**Kansas Department of Agriculture**  
**Division of Water Resources**  
 APPROVAL OF CHANGE APPLICATION WORKSHEET

RE: Filed Office Application for Change  
Water Right, File Nos. 3458

RE: Application for Change in Point of Diversion  
Water Right, File No. 3458

## GMD3 Change Review

# CHANGE IN POINT OF DIVERSION WATER RIGHT, FILE NO. 3458

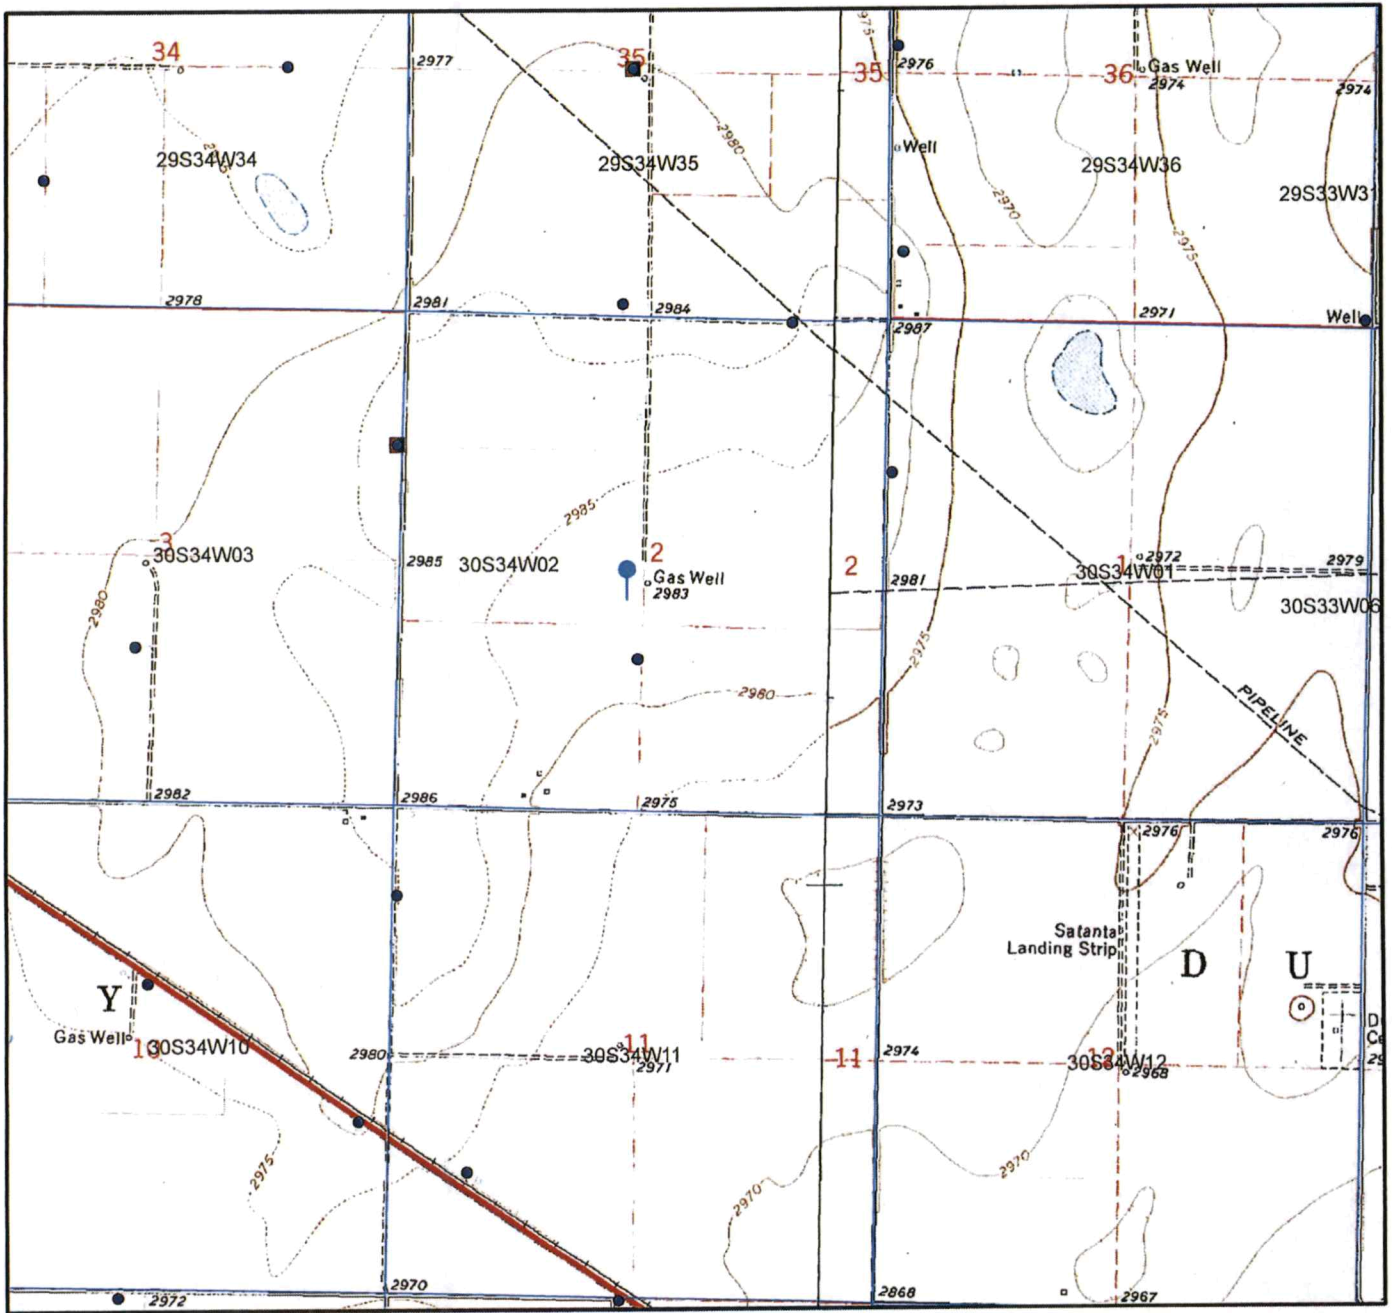
All wells of any kind within 1/2 mile of the requested place of use have been plotted.

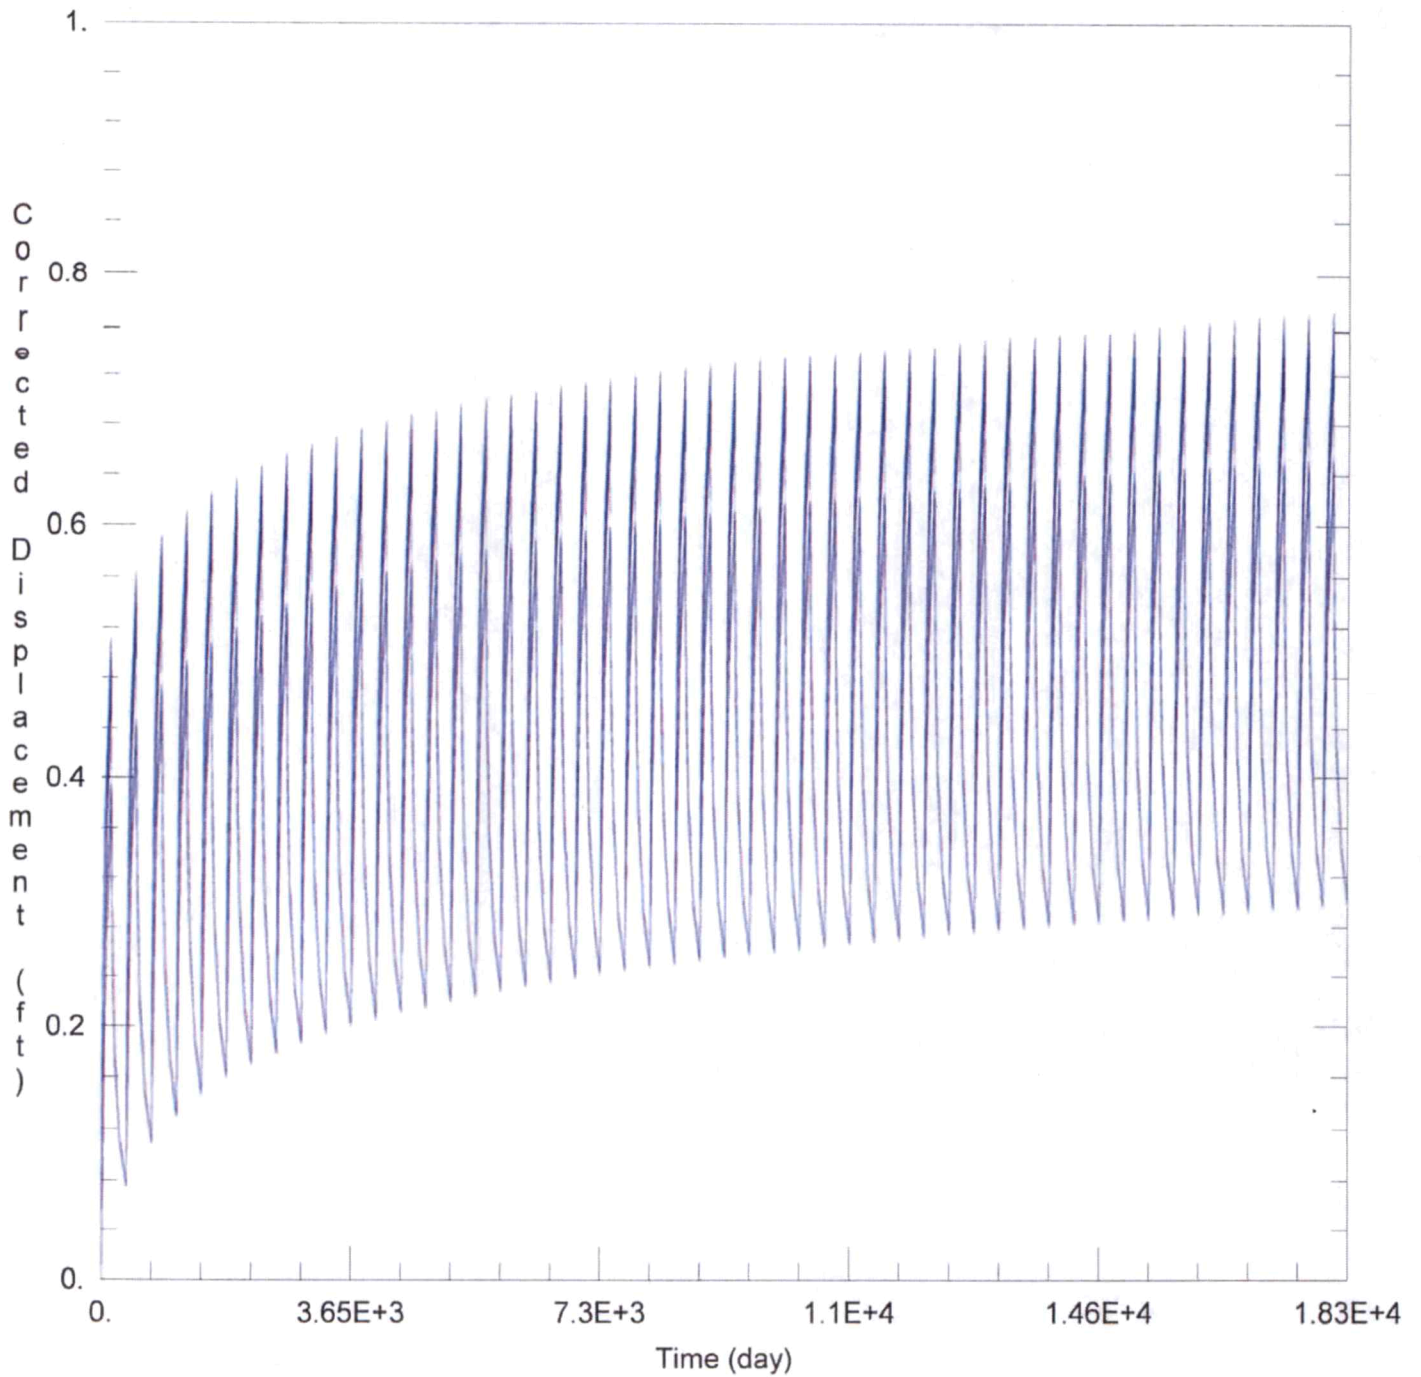
**Authorized: 640AF @ 1344gpm, 2300' minimum spacing to neighbors**

**Well not running during most recent GMD3 inspection**

**600gpm reported on 2017 WUR**

**Avg water use (2014-2023): 330.055AF/year**

Is a waiver needed: Move is less than half mile. Minimum spacing to neighboring wells appears met. Analysis shows possible effects within guidelines, no critical wells.

Recommendation: After review of available information, it appears current area rules are met. Staff therefore recommends approval of the application.
